JONATHAN THORTON
ADDITION

FIRST FLOOR = 212 SCREEN PORCH = 236

> FIRST FLOOR PLAN SCALE 1/4" = 1'-0"

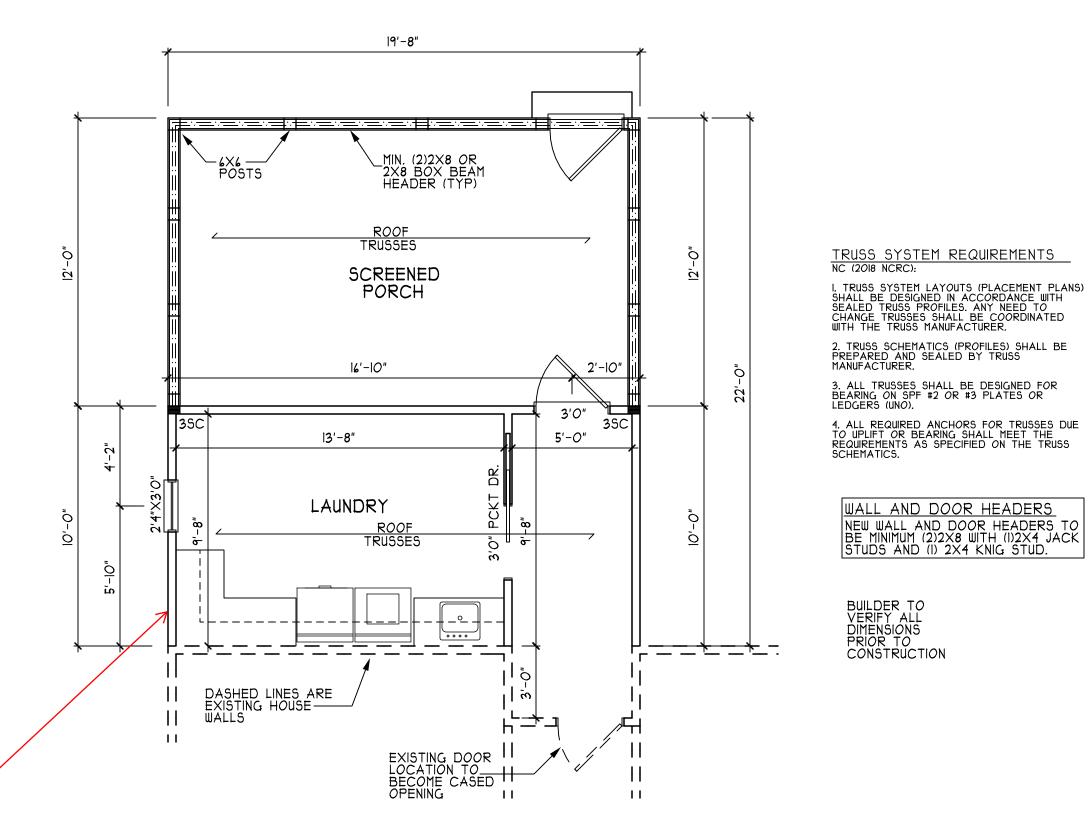
Verify addition is not closing off any sleeping room egress windows
